Redevelopment Agency Staff Report

Subject: **DR16-08 GETTLER-RYAN INC (APPLICANT), CHEVRON PRODUCTS CORPORATION (OWNER), SRB ZONING**: Request for demolition approval pursuant to Redevelopment Agency Resolution R2006-01 to demolish the existing Chevron gas station located within the Lafayette Redevelopment Area at 3632 Mt. Diablo Blvd. APN 243-060-018

RE: Letter of Response
Chevron Service Station #9-5890
3632 Mt. Diablo Blvd.
Lafayette, CA

SHEET
EC1
OF 3 SHEETS

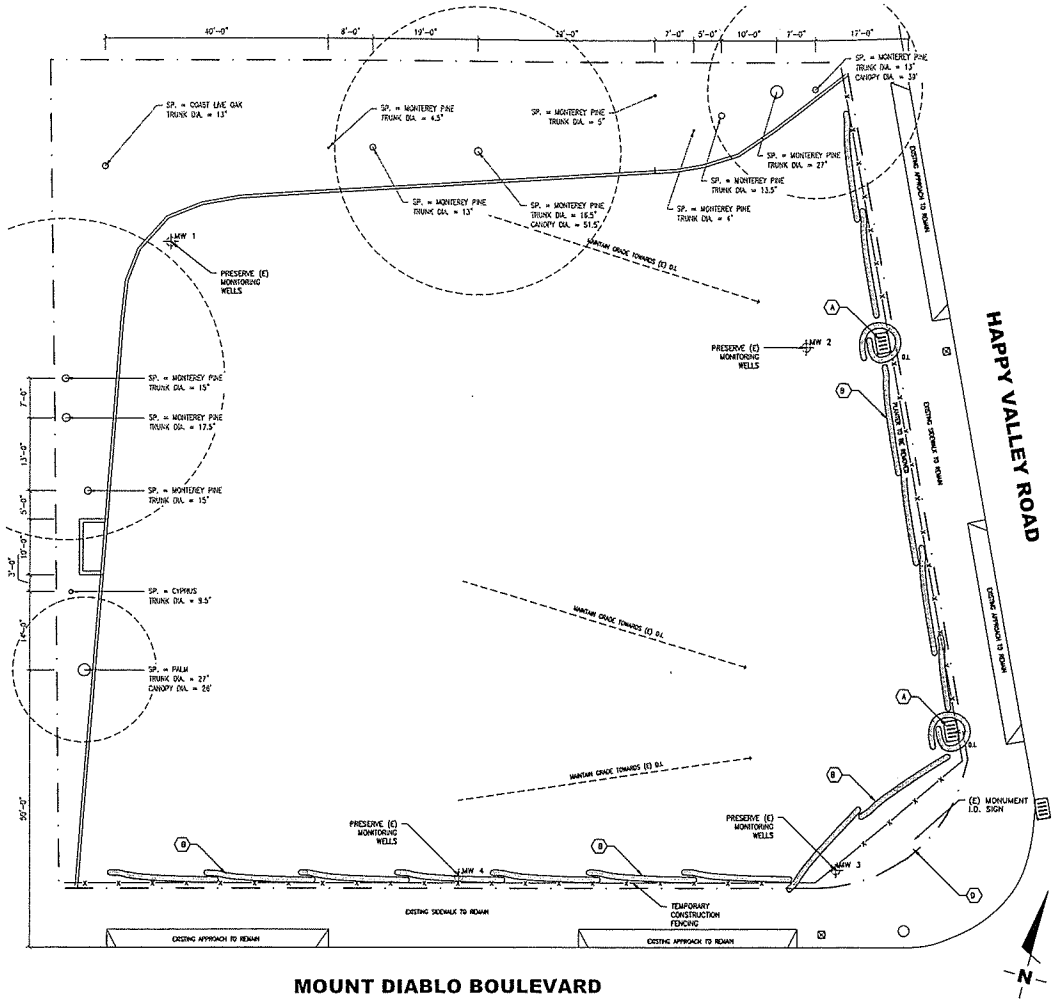
1. **Submit a storm inlet protection detail to be maintained in place after construction. The protection should be sufficiently durable to minimize the need for frequent maintenance and replacement. Consider an installation of hollow cinder blocks filled with drain rocks and wrapped in filter fabric.**

3. **Designate and provide a detail for a construction entrance in the event that work occurs during wet weather. Consider a truck route entering the site from Happy Valley Road via Deer Hill Road using the northern most driveway on Happy Valley Road, and exiting the western most driveway to travel westbound on Mt. Diablo Boulevard.**

4. **Provide a permanent security fence around the site after construction. The Commission should consider whether it is appropriate to specify a fence design. Similar past projects in the downtown have installed a black, vinyl coated chain link fence.**

A storm drain inlet detail has been added to Sheet EC1 and is notated as Revision 4.

Work will occur in dry weather. In the event that the project is substantially delayed, a traffic plan will be submitted for review.

4
A. PROTECT ALL EXISTING MONITOR WELLS, REPAIR OR REPLACE IF DAMAGED DURING CONSTRUCTION.
B. STRAW WATTLES ARE TO BE USED AROUND ALL DRIVEWAYS AND DRAIN INLETS AS REQUIRED BY LOCAL REGULATORY AUTHORITIES. WATTLES TO REMAIN UPON PROJECT COMPLETION TO MAINTAIN EROSION CONTROL.

SHEET
D2
OF 3 SHEETS

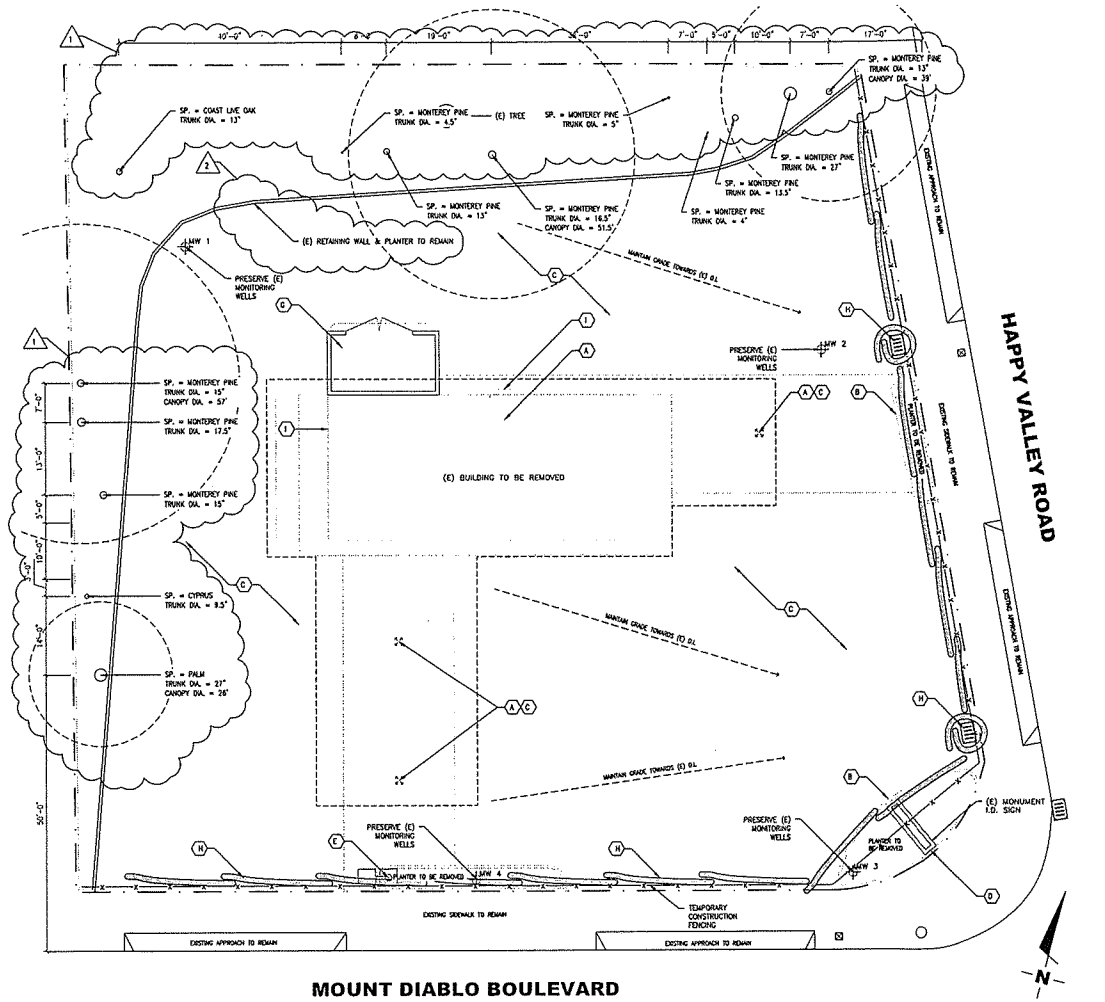
5. **General notes (#1 on sheet D2) indicates that mature trees along the west property line are to remain undisturbed. Please show location of these trees on the site plan and call out tree protection around tree dripline. Removal of planter may adversely impact these trees. Also, removal of the retaining wall may compromise existing slope that it's retaining. Consider maintaining the planter.**

The trees have been noted as requested on Sheet D2. Additionally, the planter/retaining wall has been removed from the scope of work and will remain in its entirety. Finally, soil scarification noted in the General Notes (formally #19) has been removed from the scope of work. Since the planter will be retained and no scarification will occur, there is adequate buffer between the trees and the proposed demolition activities. No other protection for the trees is proposed.
